## ***Interactive comment on “Quality assurance and control on hydrological data off western Sardinia (2000–2004), western Mediterranean” by Alberto Ribotti et al.***

**Alberto Ribotti et al.**

Received and published: 21 April 2020

Fig. 2.

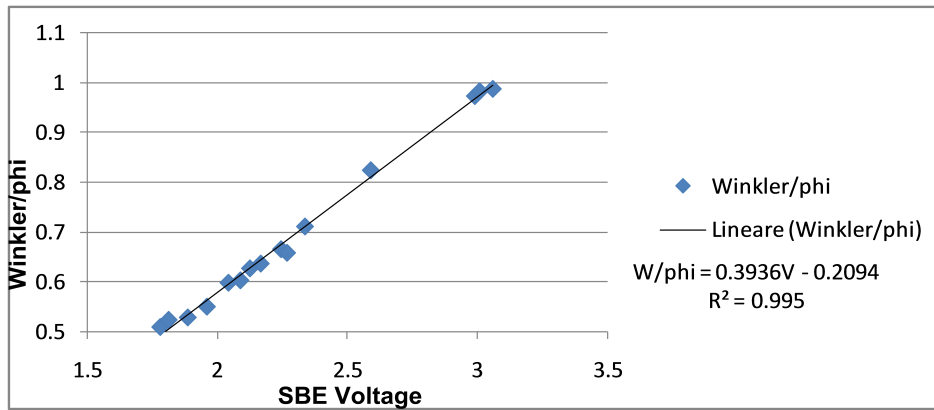
p. 14 ex-figure 4, now figure 2: changed decimal separator accordingly

Fig. 3.

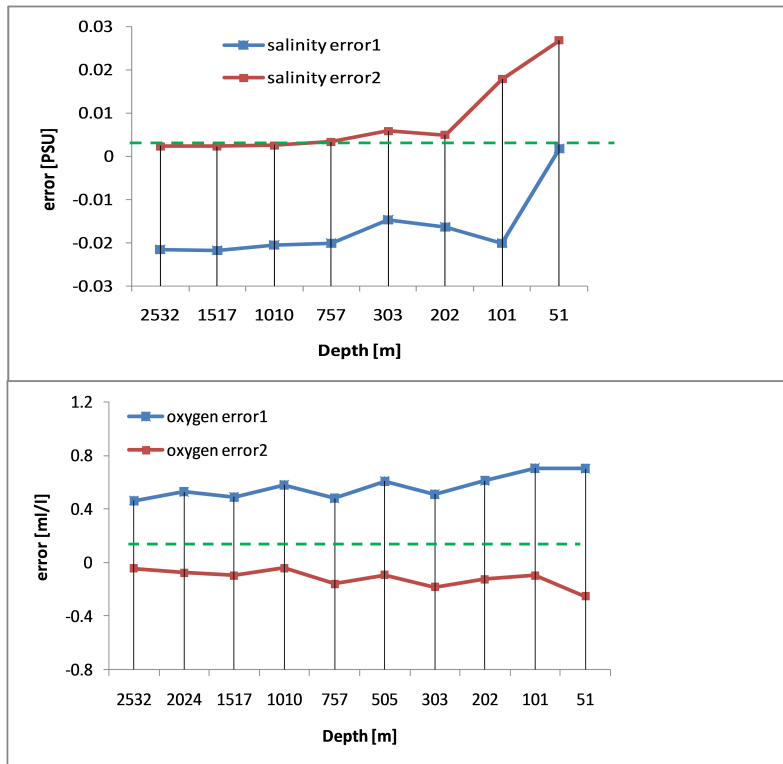
p. 15 ex-figure 6, now figure 3: changed decimal separator and depth format accordingly
